Office Action Summary

10/800,716

Claims 1, 5, 16 and 20 are rejected under 35 U.S.C. 102(b) as being clearly anticipated by Ishii et al. US 5,280,641 (Ishii).

Figure 4A of Ishii

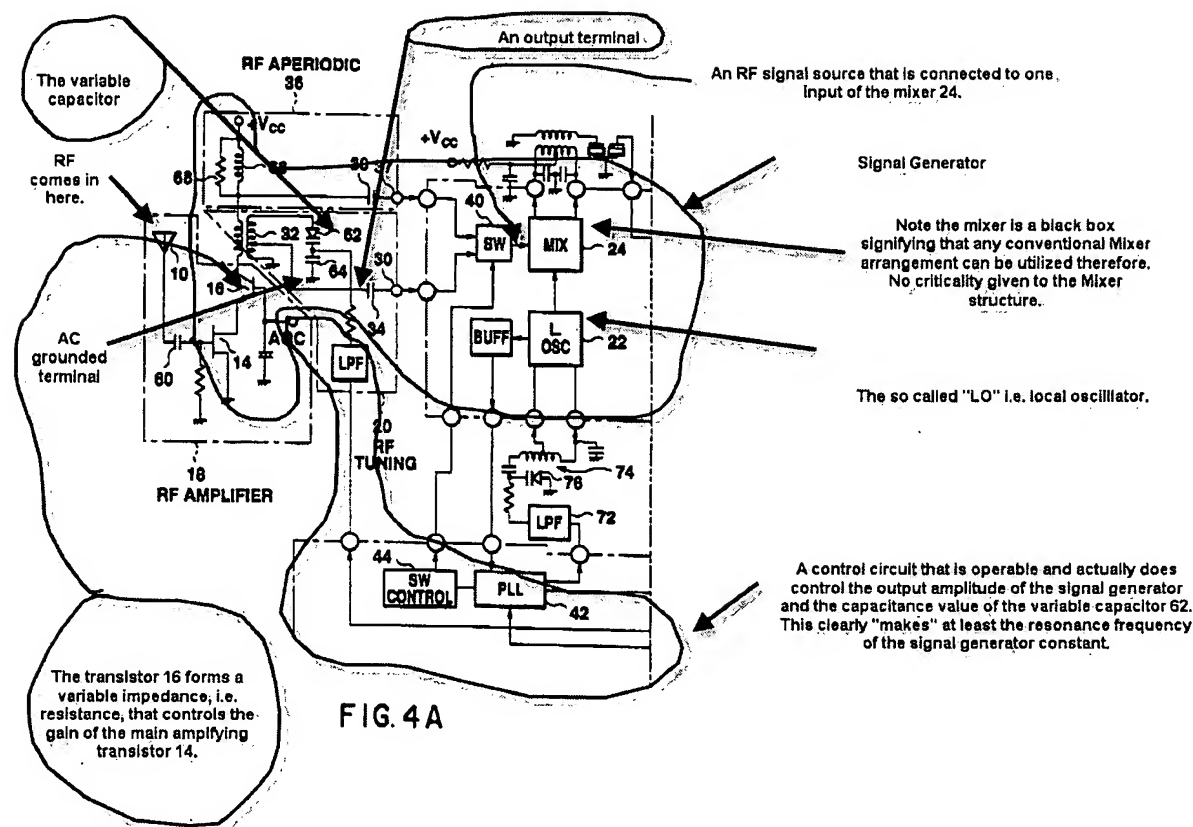
Figure 4A and the relevant text of Ishii discloses a variable gain amplification circuit having a signal generator as indicated above whereby element 16 forms a variable resistor element that is also part of the load for the source/drain of the main amplifying transistor 14. Element 62 is a variable capacitor that is connected between the output terminal i.e. the tap on secondary 32 and an AC ground, i.e. note the ground symbol. As indicated in the above the circuitry that provides the control signal for the variable capacitor and the AGC signal forms the claimed control circuit. The control signal V_T for the variable capacitor clearly controls the capacitance value of the variable capacitor 62. The claims now recite, i.e. have been amended to recite that the capacitance *makes* either the cutoff frequency or the resonance frequency of the signal generator constant. This is what happens in Ishii. Note that although the signal V_T may vary for a short period the value the signal does settle down to a single value and remains there

till the tuning point is changed thereby making the resonance frequency of the signal generator constant that also corresponds to the maximum point of signal strength.
